Cockpit Barn
Knowle Lane, Horton Heath

Drainage Summary for Discharge of Condition
October 2025

Application Ref is F/23/94713

Appendices A Drainage Plan – Planning Stage

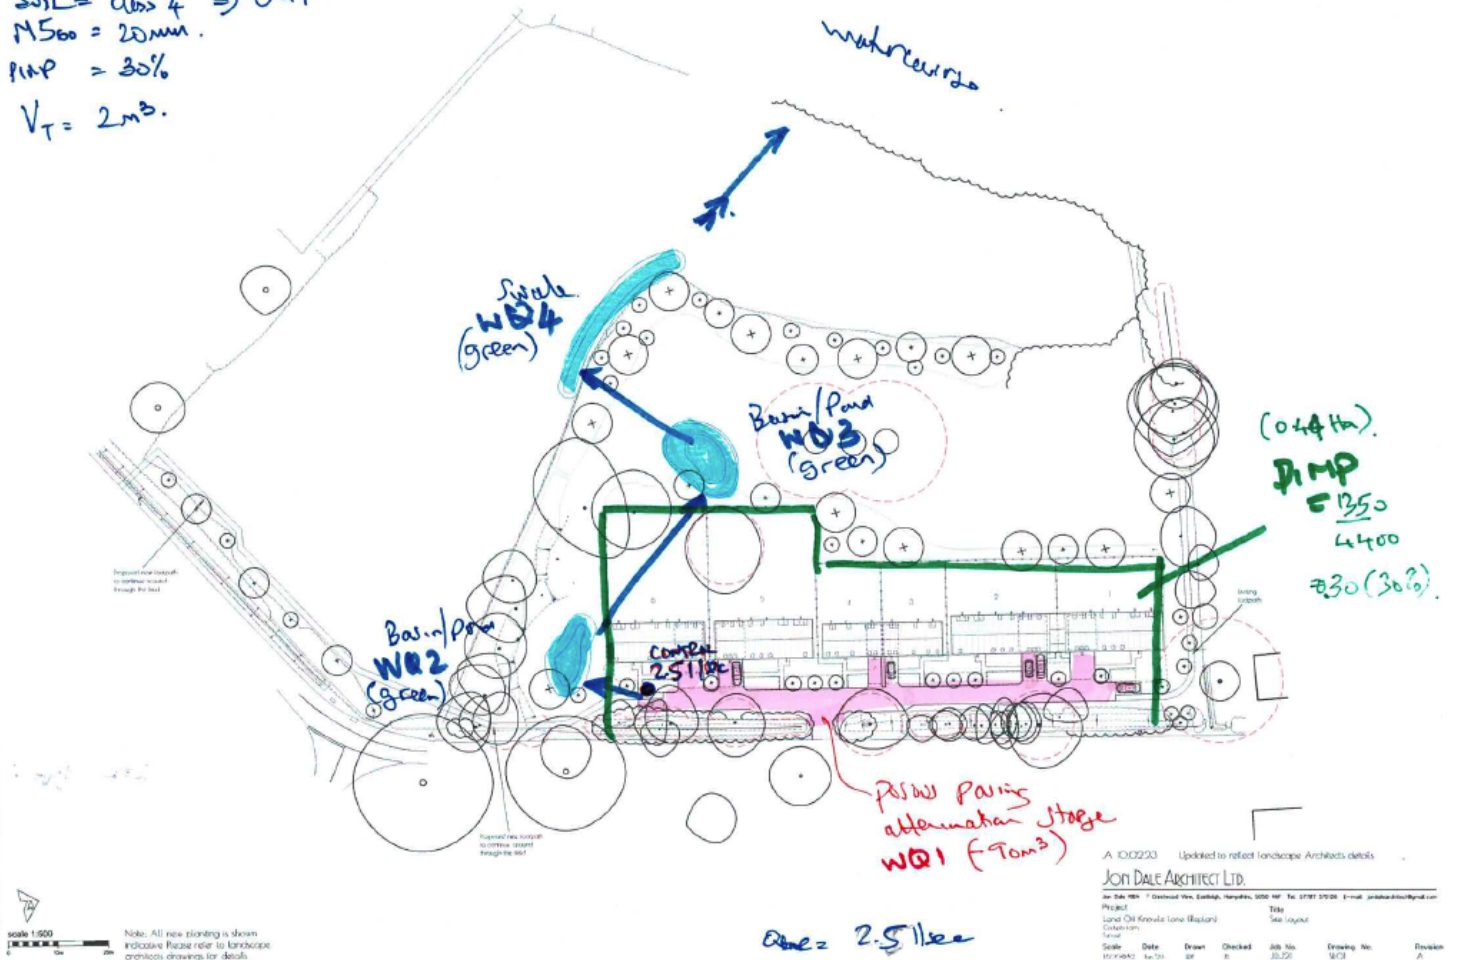
The principal modification involves the removal of the basin adjacent to Plot 6. This has been replaced with underground cellular storage to provide attenuation prior to discharge via a hydro-brake flow control into the existing basin.
